April 2019 Environmental Update for SLEMA Board

May 3, 2019

Fig 1 Closure Timeline

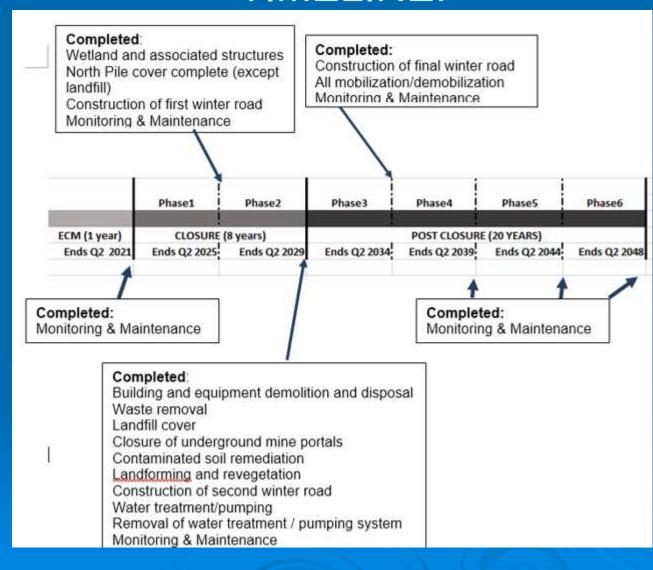
However, according to Figure 2 (Closure activities completed) the costs executed by the end of Phase 1 is CAD 25,048,628.66

And the cost executed by the end of Phase 2 is CAD 46,571,094.

There is a difference in the proposed staged reduction of security (Table 10) and the activities completed or executed during periods 1 and 2.

A reduction in security may occur when a reclamation component is completed and/or after a set monitoring duration is completed, for the amount required to complete the activity.

Also, the request for security reduction should be accompanied by

"Credible evidence that the reclamation objectives for that phase or component were achieved as planned"
